Serial No.: 10/808,532

Docket No.: 100353-00185

REMARKS:

FIG.1 (PRIOR ART)

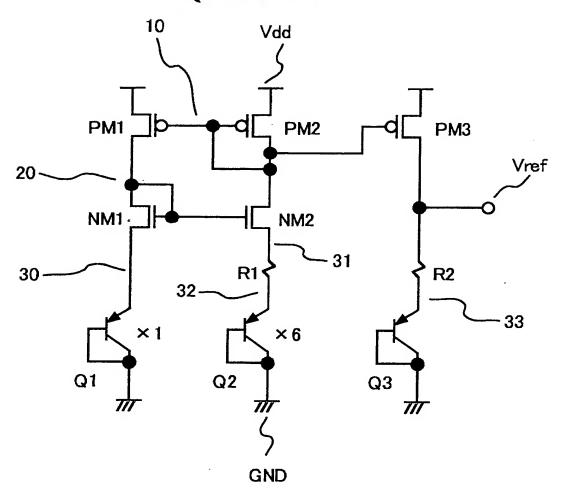
The Examiner objects to Figures 1-4 as allegedly failing to include a "Prior Art"

legend. In accordance with the Examiner's suggestions, Applicants have amended

Figures 1-4 to include a "Prior Art" legend. Therefore, Applicants respectfully request
